# Access Compliance Report

## Public Rights-of-Way

### (Curb Ramps)

| Intersection ID: 19826 | Main Street: THERMAL_RD | Cross Street: PATIMBY_RD | Location: NE           |

| ADA ID: 16ACB836FD3E   | Ramp Type: PerpDiag     | Initial Pass/Fail: Fail  | Overall Compliance: No |

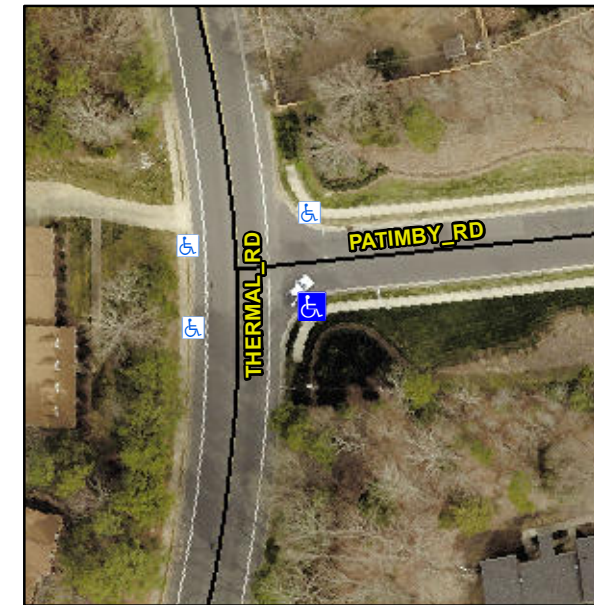
**Not Found, R304.2.2, R304.5.3**

| Compliance | Description           | Data | Compliance | Description                 | Data |
|------------|-----------------------|------|------------|-----------------------------|------|
| N/A        | Ramp Length (in)      | 47.0 | No         | Ramp Slope (%)              | 10.8 |
| Yes        | Ramp Width (in)       | 48.0 | No         | Ramp XSlope (%)             | 6.2  |

**Remove & Replace Curb Ramp With Two New Directional Ramps or Equivalent.**
